Re: Response to Comments | City of Portsmouth Wetland Conditional Use Permit Request | Tax Map 255, Lot 2 | 0 Banfield Road (with frontage on Peverly Hill Road), Portsmouth, New Hampshire

On behalf of the applicant, Chinburg Development, we are pleased to submit this response to comments and suggestions included in a July 3, 2025 Memo, from Kate Homet and Peter Britz, to the Conservation Commission Members in preparation for the July 9, 2025 meeting. The comments and suggestions are included below in *Italics*, followed by our responses in **Bold** text.

This application is for the installation of residential driveways, underground utility piping, and at-grade stormwater management BMPs for an undeveloped site that is to be subdivided and developed into five single-family residential properties. This project proposes 6,676 s.f. of permanent disturbance to the 100' wetland buffer.

SUBDIVISION SITE PLAN
TAX MAP 255 - LOT 2

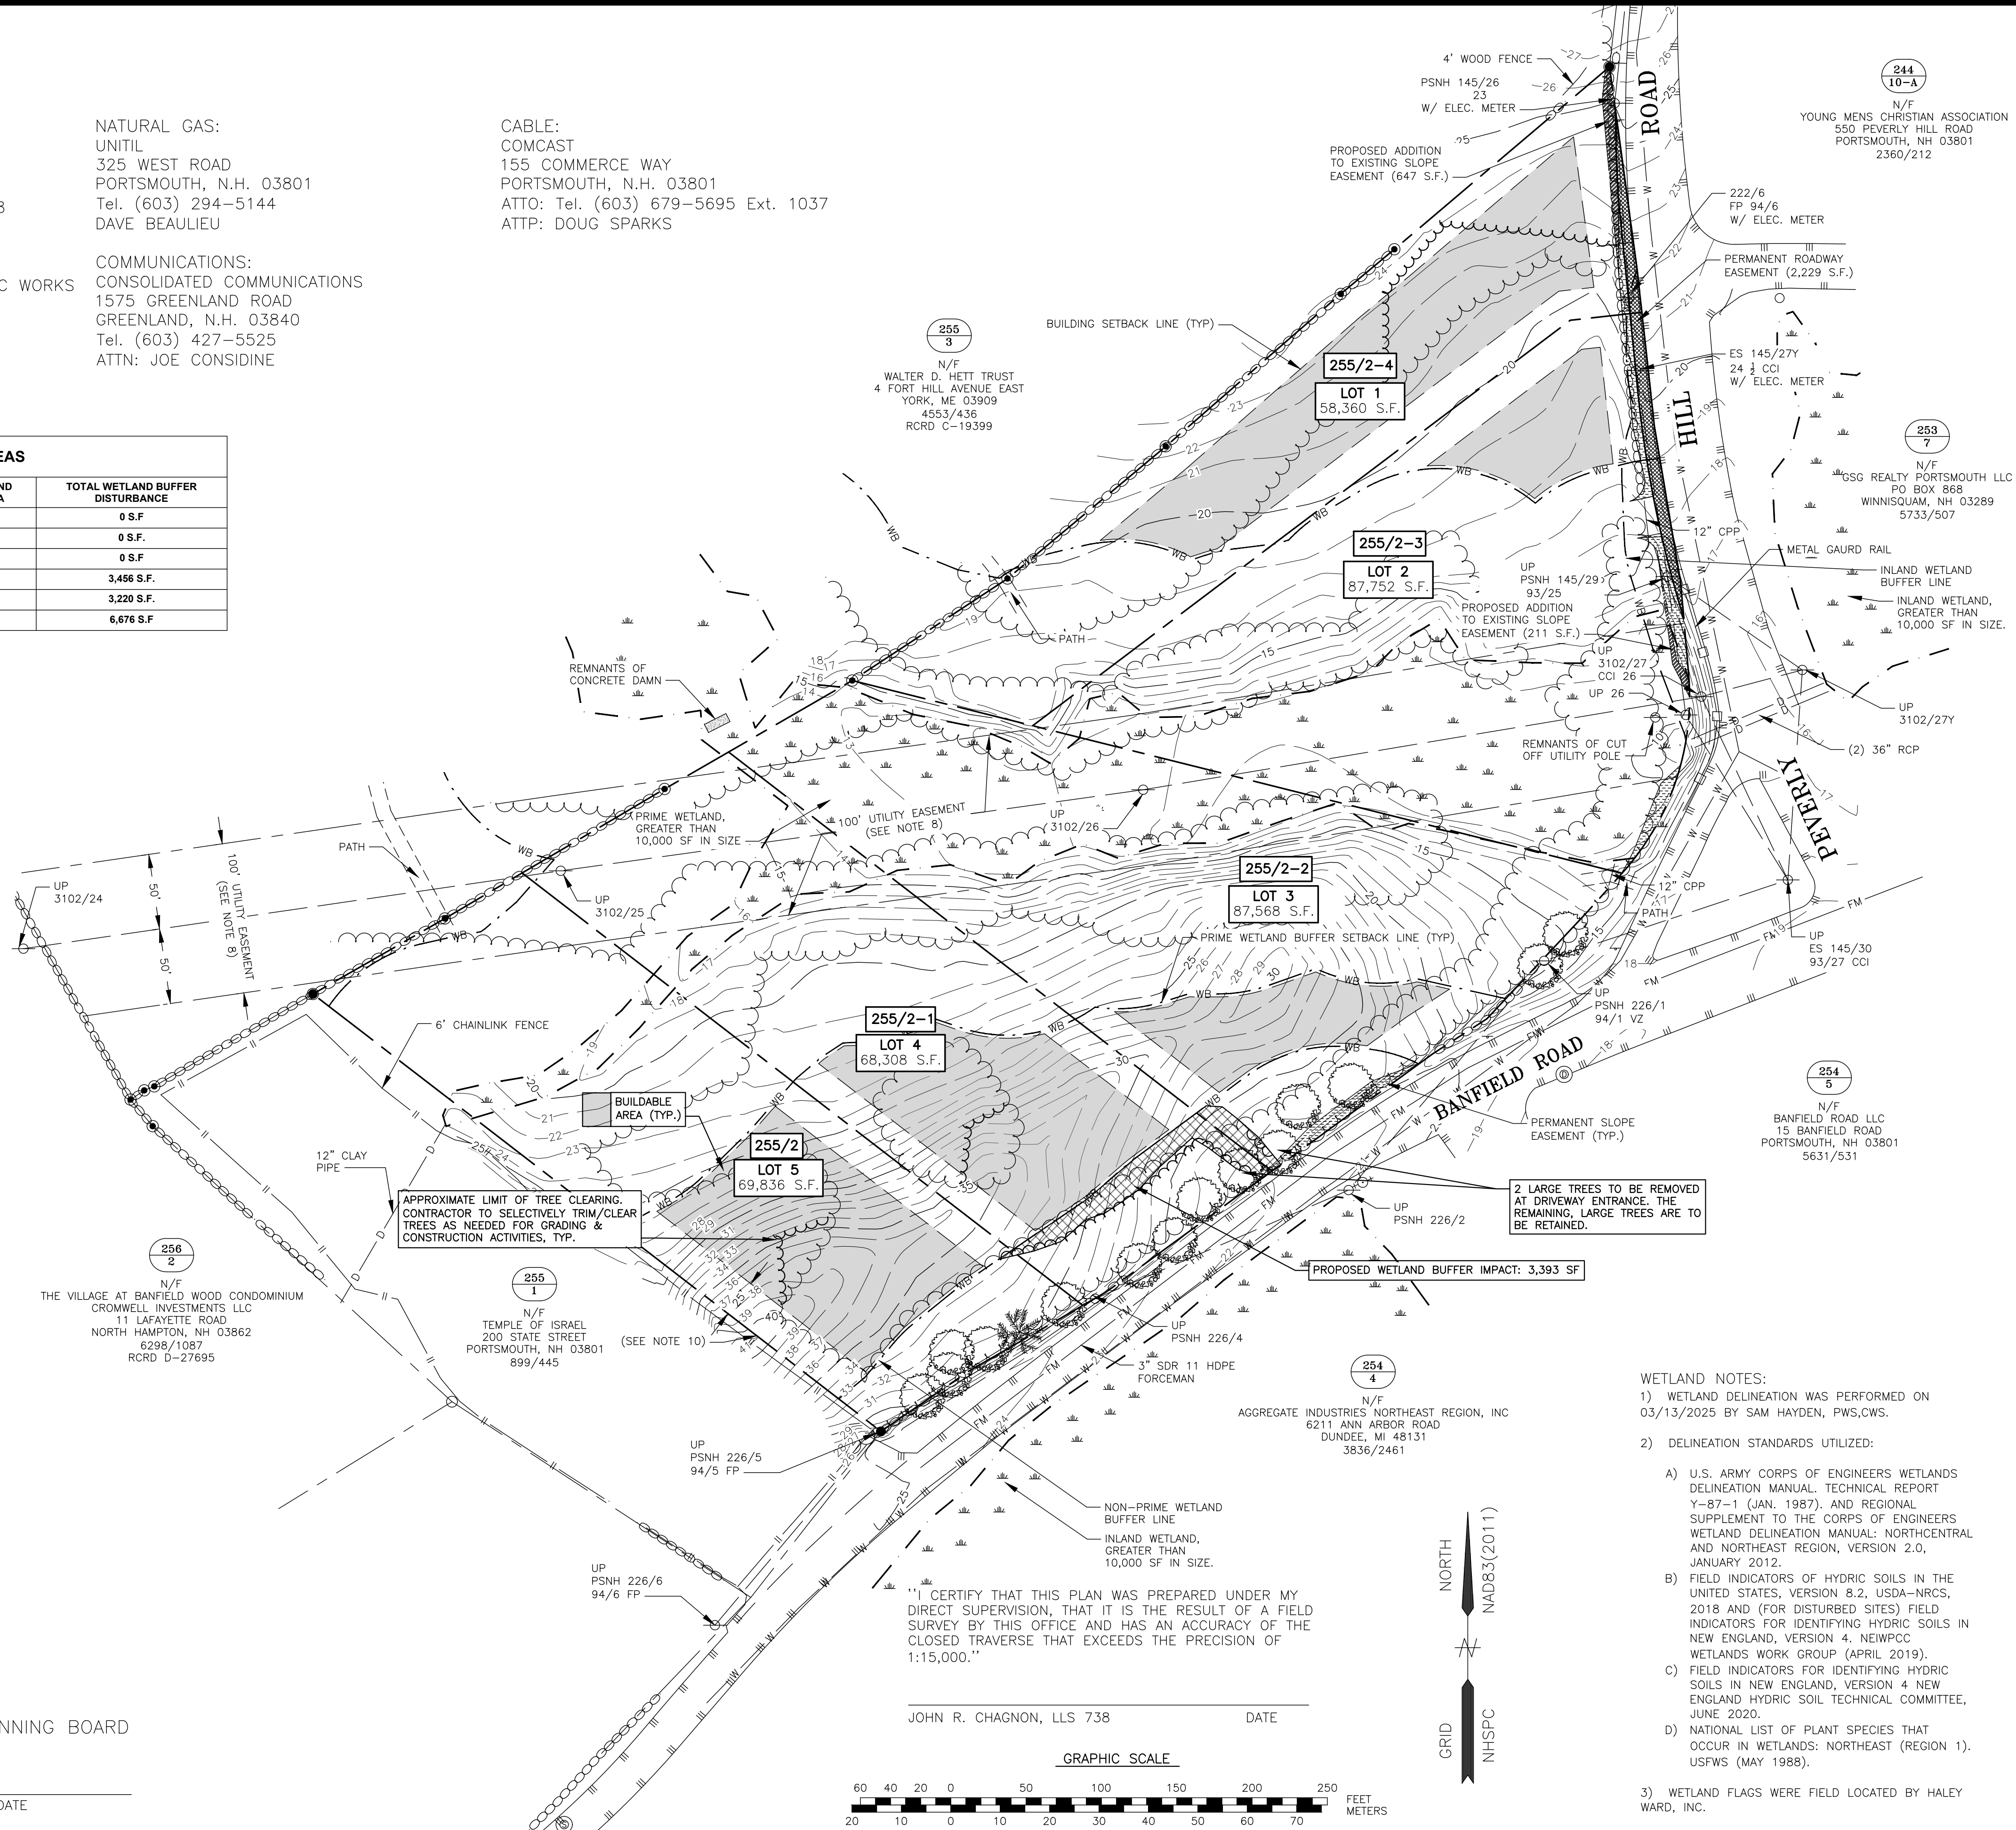
6. *Applicant should propose buffering or protection along each of the lots that protects the natural vegetated state of the prime wetland and its 100' buffer to the rear of the site.*

The Subdivision Plan indicates the boundaries of the wetlands and associated buffers. The building setback lines are shown to be outside of the wetland buffer limits. Notes indicating the existence of the buffers and wetlands are included on the plan as well. Future lot owners will be subject to following zoning regulations, including those related to the wetlands and associated buffer areas.

**EROSION CONTROL PLAN
TAX MAP 255 – LOT 2**

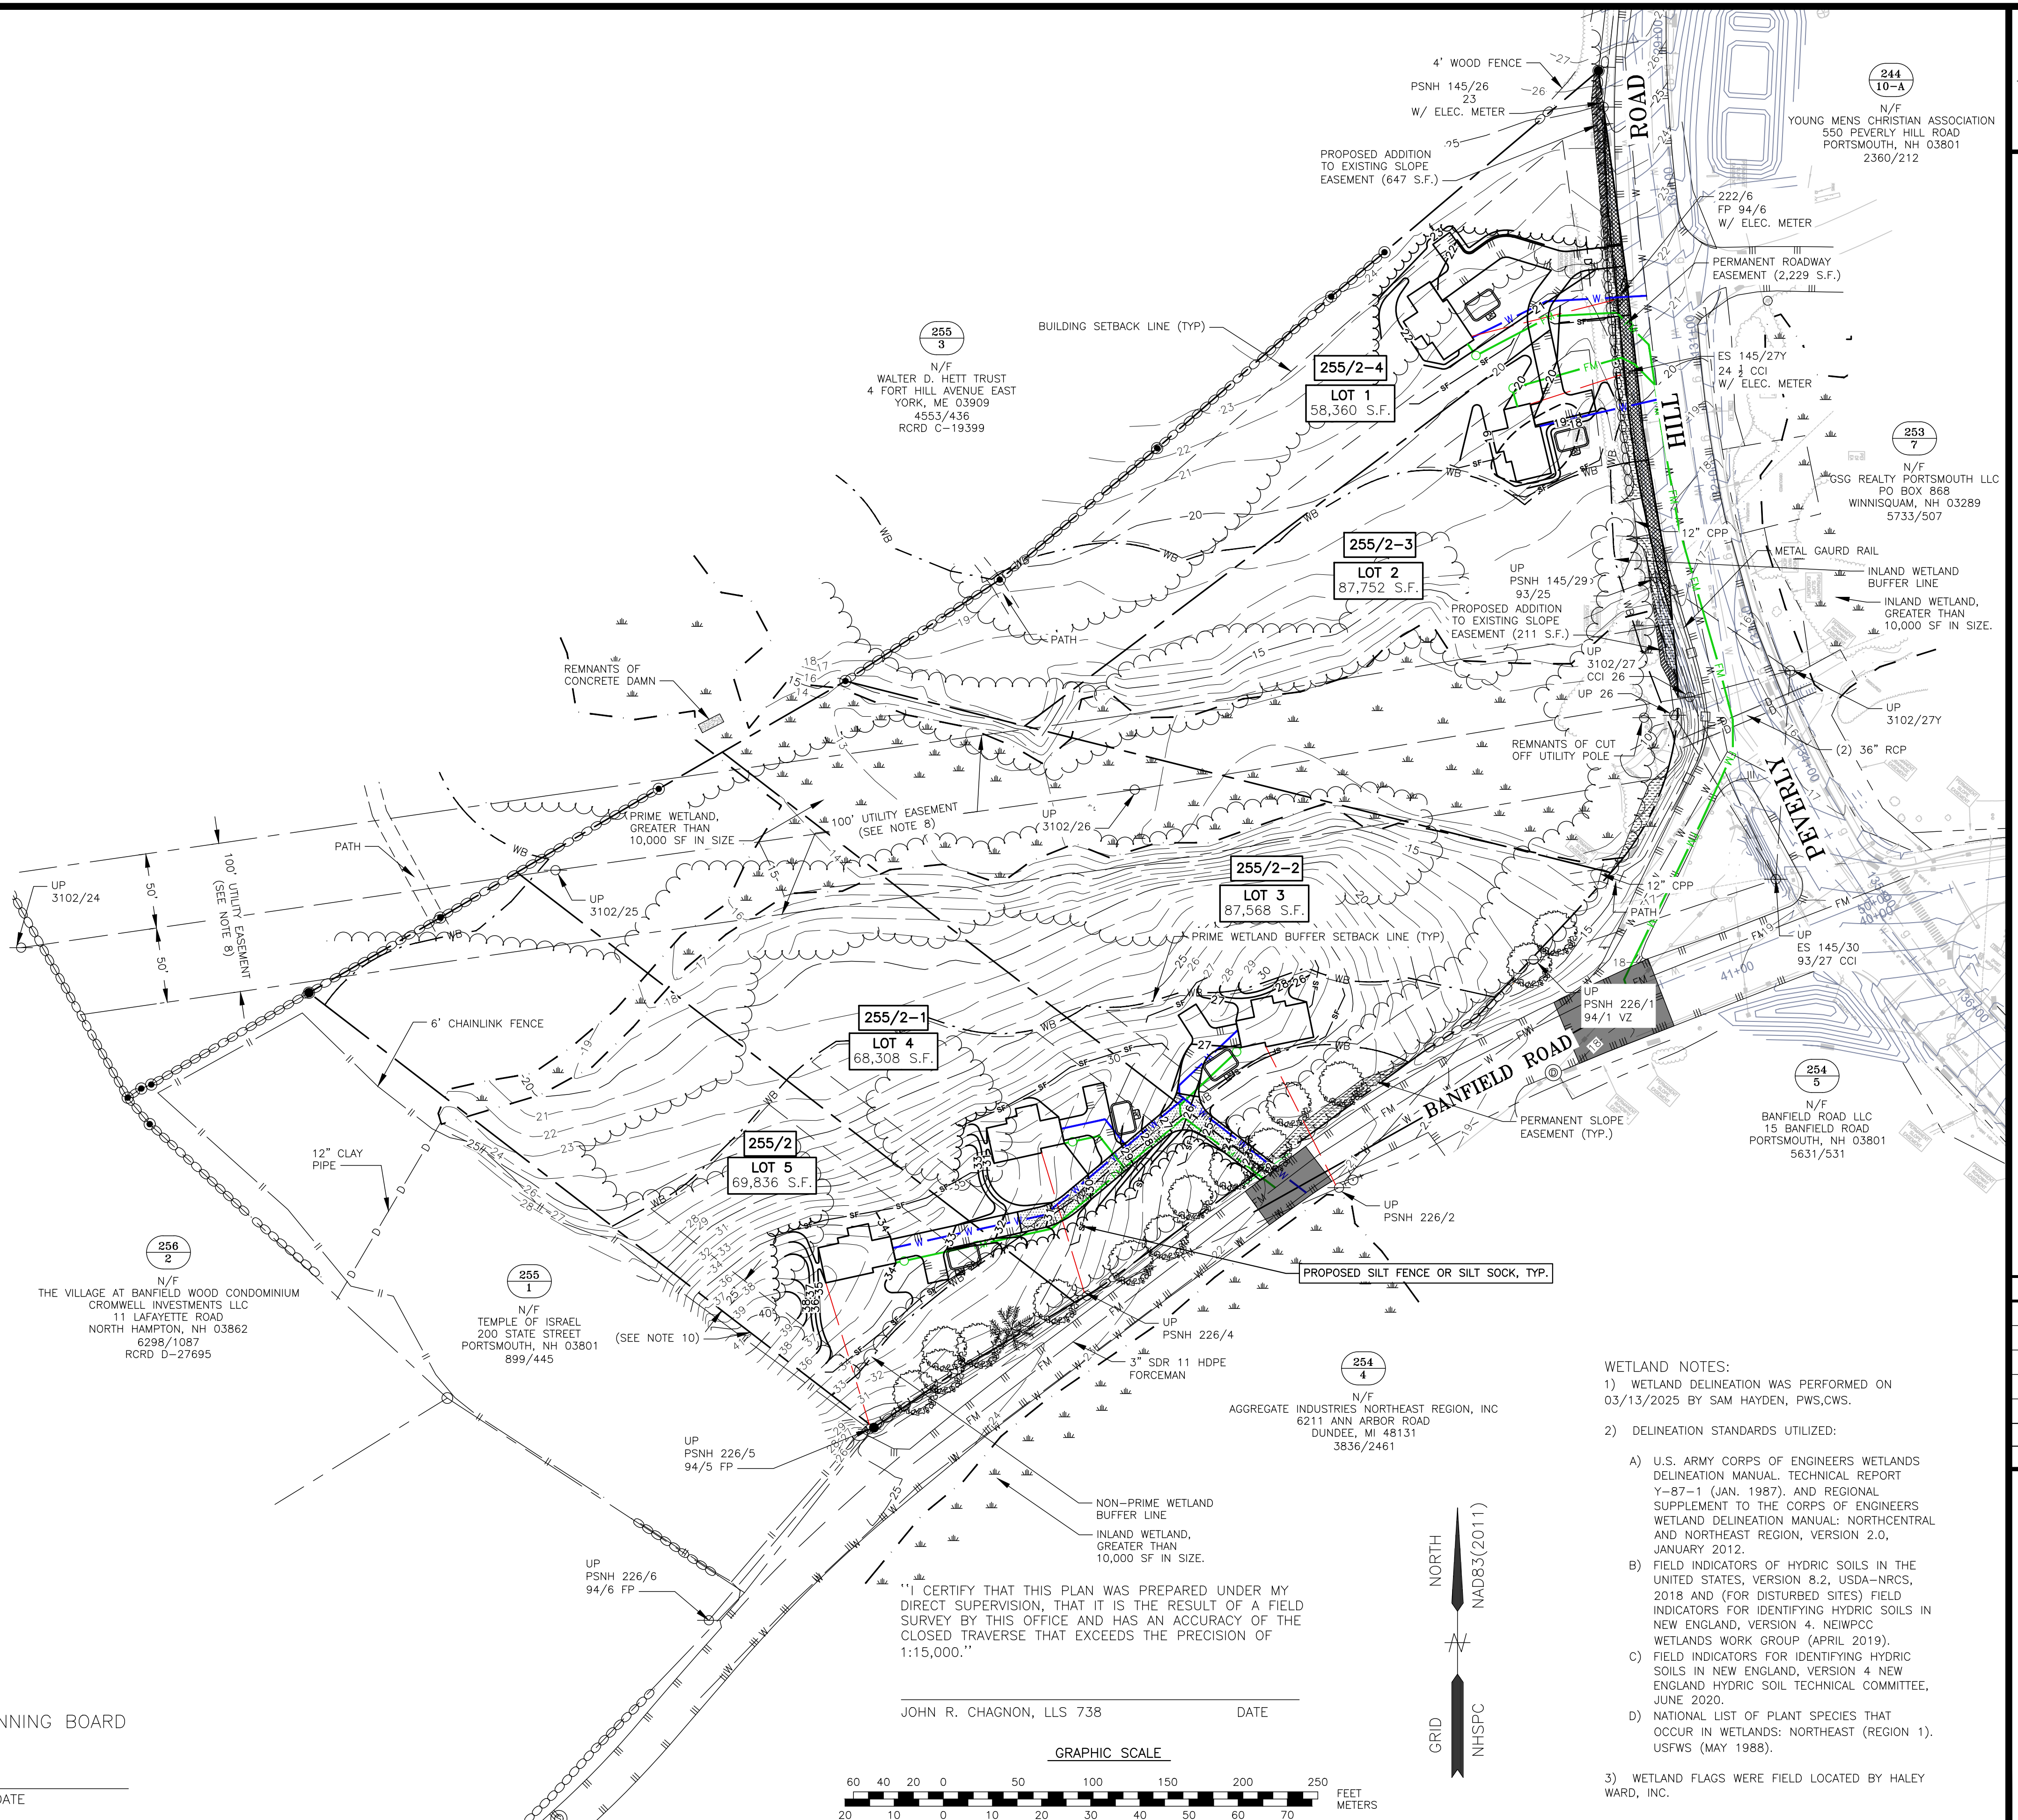
4. *Erosion and sediment control plans must be included in this application, not just the building permit phase.*

An Erosion and Sedimentation Control Plan has been created for this project and is attached for your review.
